February 14, 2020

**Subject: Response to Agency Comments on *Vapor Intrusion Assessment and Work Plan* dated September 27, 2019, Tyco Fire Products LP, Stanton Street Facility, Marinette, Wisconsin, WID 006 125 215**

**Exhibit 1. GWCTS Office and Support Areas**

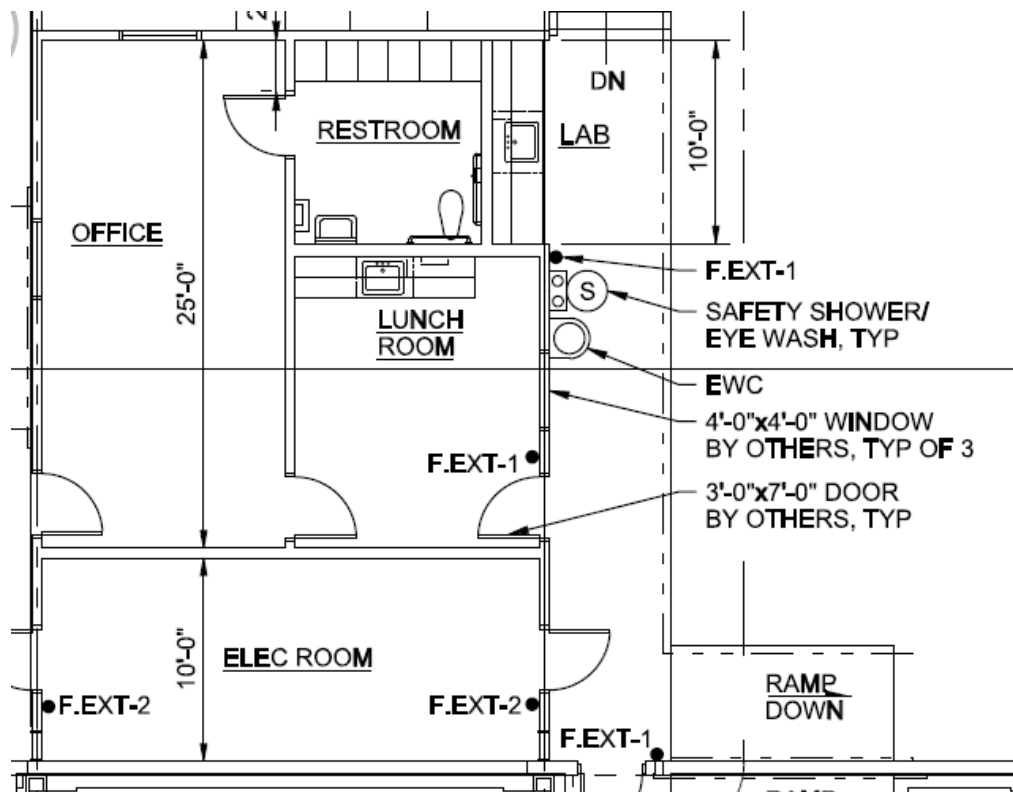
**16. Page 9, Section 4.3, bullet 1:** *Two sub-slab probes are proposed for installation in the "office and lunch room areas" of Building 14. The office is described to be "only 800 square feet" however, it is unclear if the lunch room is included, or if it is a separate space. Please clarify the square footage of each space and whether they are combined. Although two sampling locations may be sufficient for an 800 square foot area, additional information must be submitted to support this number. Building 14 was constructed in 2010 but the site had a long history before then. Please detail what activity occurred within the footprint of this building prior to construction that might have a bearing on the variability of sub-slab conditions and therefore the number of probes needed to characterize sub-slab vapor concentrations. This assessment should not delay the initial sampling in Building 14.*

**Response:** The approximately 800 square feet includes the office (approximately 300 square feet), lunch room (approximately 180 square feet), restroom (approximately 100 square feet), and electrical room (approximately 250 square feet), which are separately enclosed areas from the treatment area that constitute office- or support-type areas. Exhibit 1 provides a sketch of the space layout.

Revised Figure 3  
Attachment – QDF

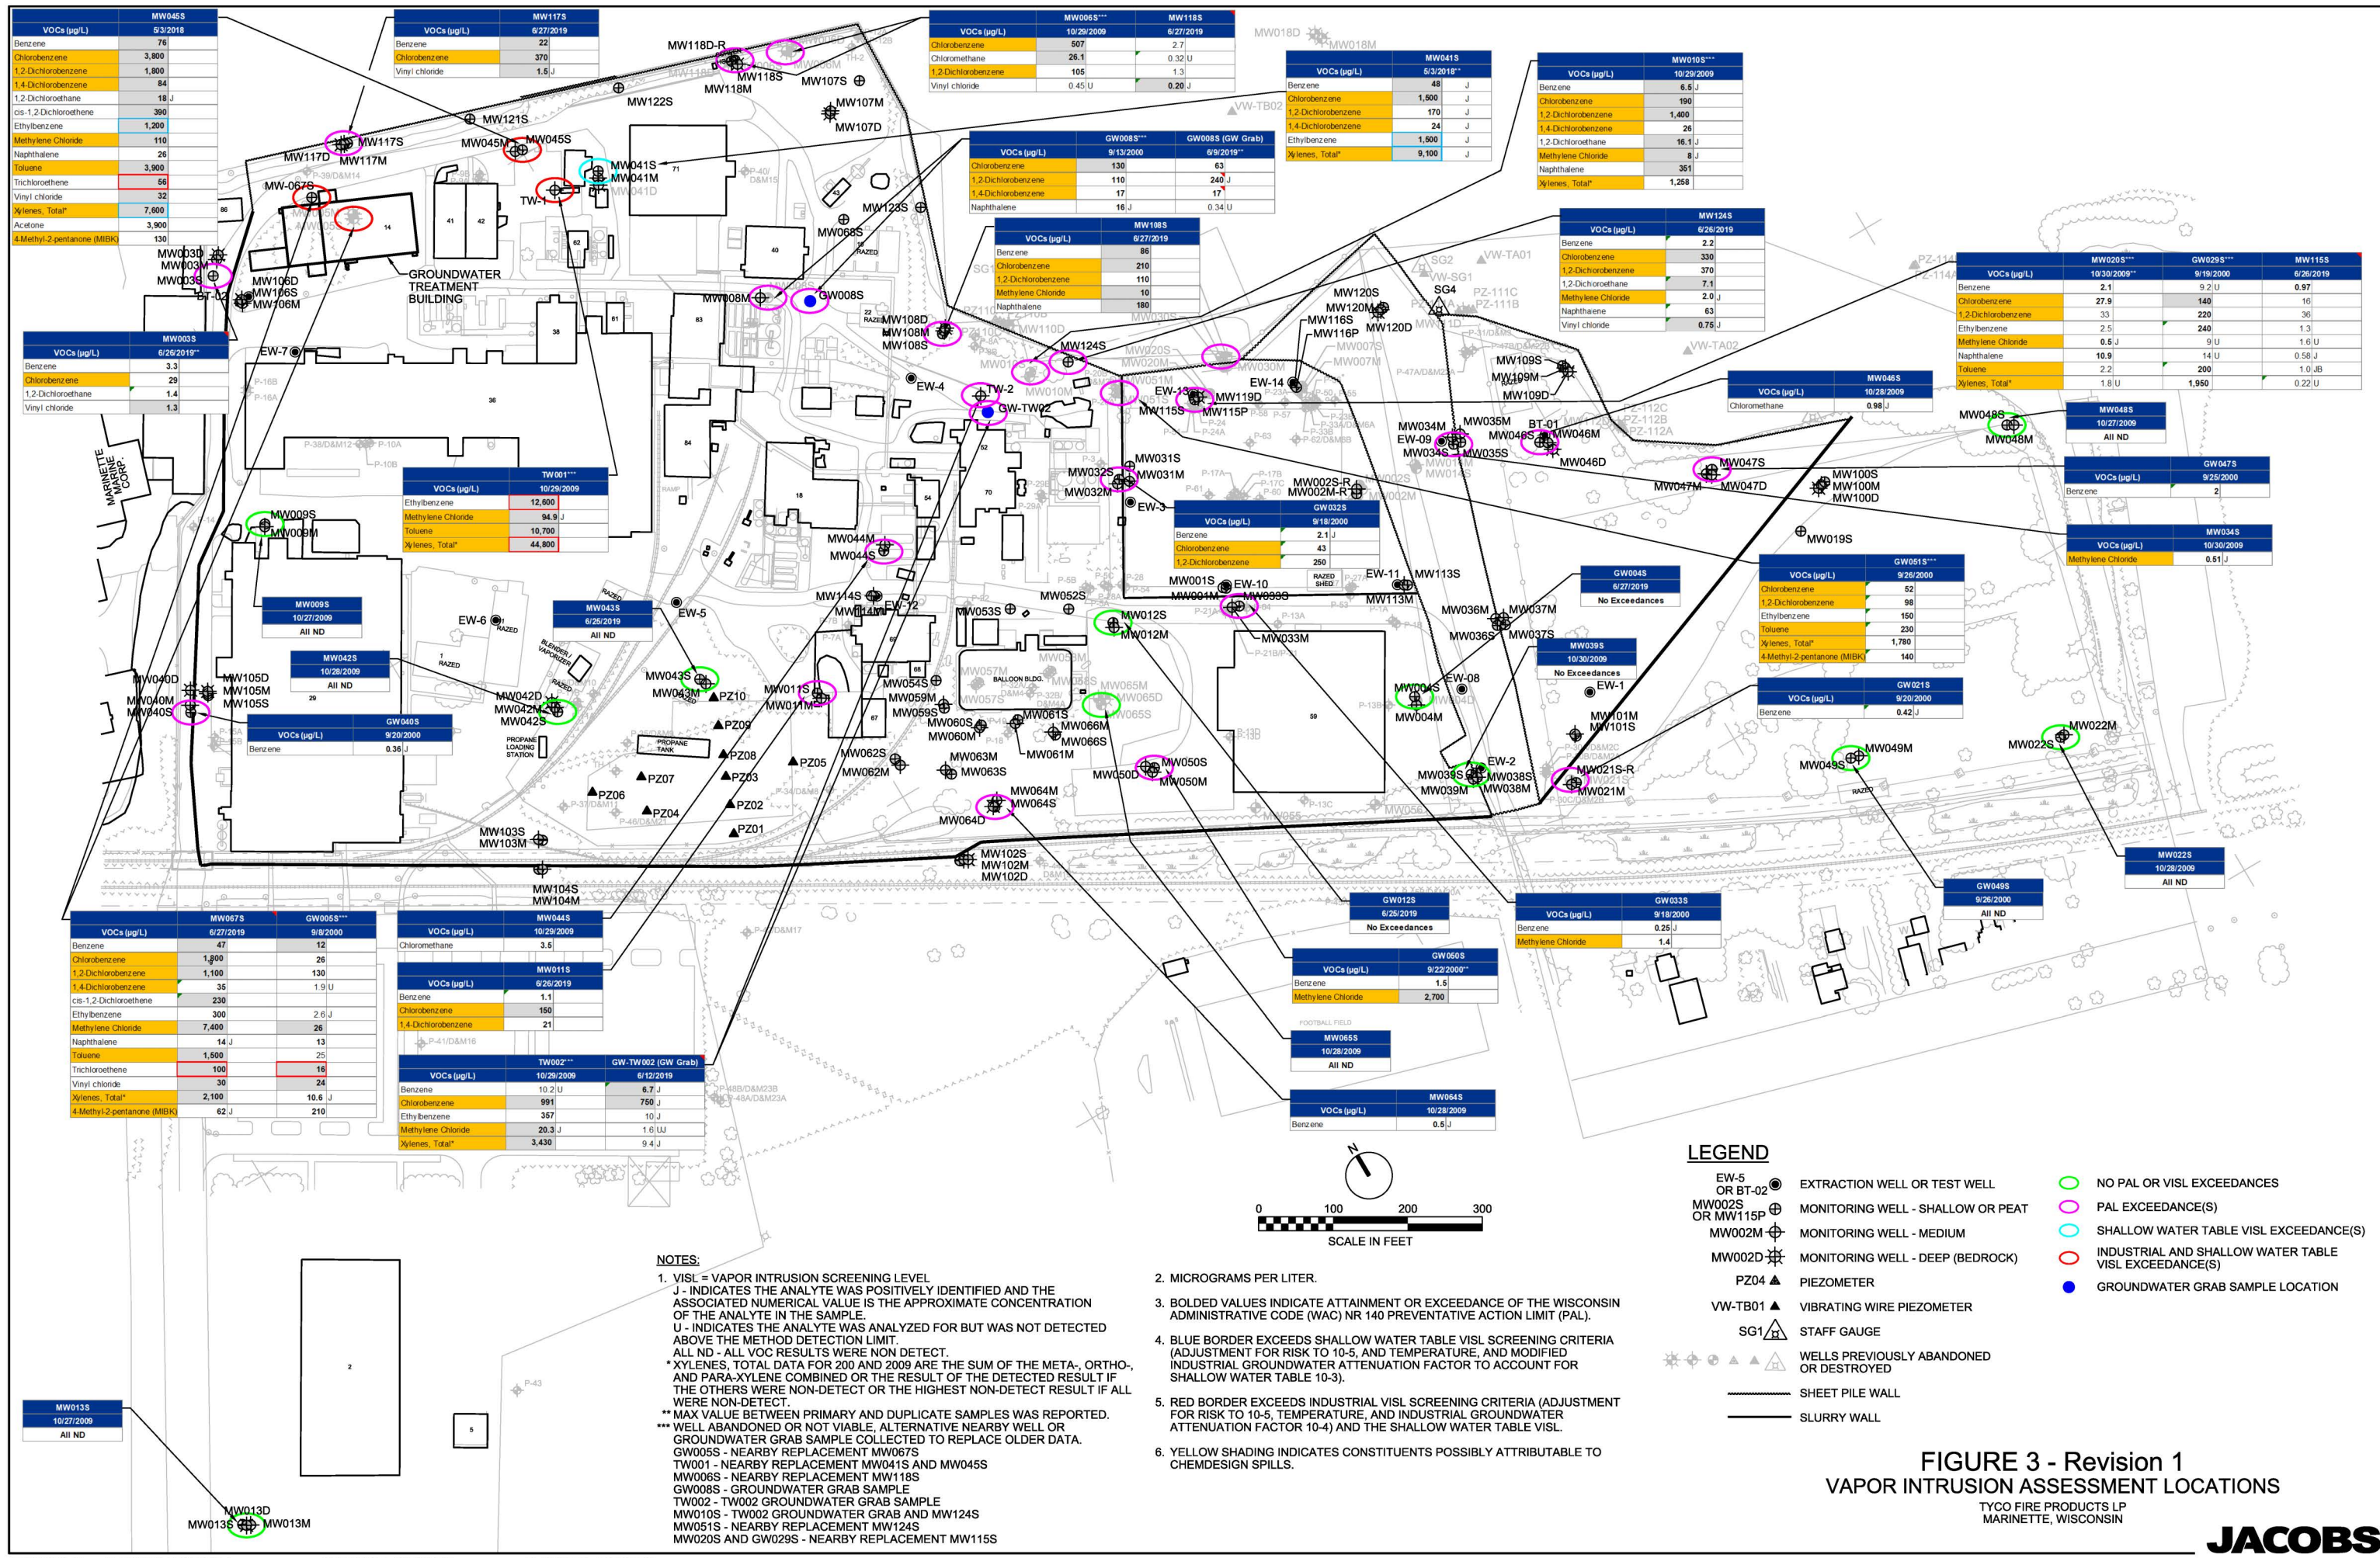
**4. Page 2, Section 2, paragraph 2:** *A comprehensive evaluation of the potential for VI at this site should include areas where groundwater comes in contact with building foundations. The VI Work Plan did not provide any information on groundwater gradients within the containment system, nor did it contain an assessment of groundwater elevations in relation to the foundations of site buildings, including whether any of these buildings have features such as sumps that would increase the likelihood of VI. The description of the hydrogeologic setting on page 2, paragraph 2 states that groundwater within the containment area occurs within a few feet below ground surface. It also states that the operational criterion of the extraction wells is to maintain the water table at levels below the ground surface to prevent site flooding. It seems possible, given this situation, that the slabs of at least some of the buildings may be in contact with groundwater. If this is the case, it changes the criteria for screening for both chlorinated volatile organic compounds (CVOCs) and polar volatile organic compounds (PVOCs). For CVOCs, the threshold becomes the NR 140 Preventive Action Limit for all compounds, instead of the Enforcement Standard for PCE and TCE, and the groundwater vapor risk screening level (VRSL) for all other compounds.*

**8. Page 3, Section 3:** *The desktop evaluation of VI started with known areas of groundwater contamination and then evaluated whether buildings or utility lines were within screening distances to those areas. In the decision matrix in Section 3.1, the first bullet indicates that existing groundwater quality data were reviewed to identify shallow monitoring wells where the concentrations of one or more VOCs exceed calculated VI screening levels. The set of existing groundwater quality data appears to include sampling events from 2000 through 2019. Figure 3 illustrates locations where VOC sampling has occurred from 2000 through 2019 and no vapor intrusion screening level (VISL) exceedances exist. In some cases, this provides historical perspective on VOC contamination but does not define the current risk. Figure 3 should be updated to clarify the dates the samples were collected for the VISL evaluation.*

The groundwater analytical data provided in the work plan (Jacobs 2019, Table 2) already compares VOC concentrations measured in the site monitoring wells to the Wisconsin Administrative Code § NR 140 preventive action limit (PALs). The attached figure, which is a revised version of the figure provided in the work plan (Jacobs 2019, Figure 3), shows locations where PAL exceedances were identified for at least one VOC at a given monitoring well during its last sampling event (2019, if available; otherwise past data). As shown on the revised figure, the number of monitoring wells near buildings where PAL exceedances were identified is substantially greater compared to those with VISL exceedances that were highlighted in the initial work plan.

**Response:** The dates of the sampling results for each location are included in Table 2. A revised Figure 3 also is attached that includes the dates sampled.
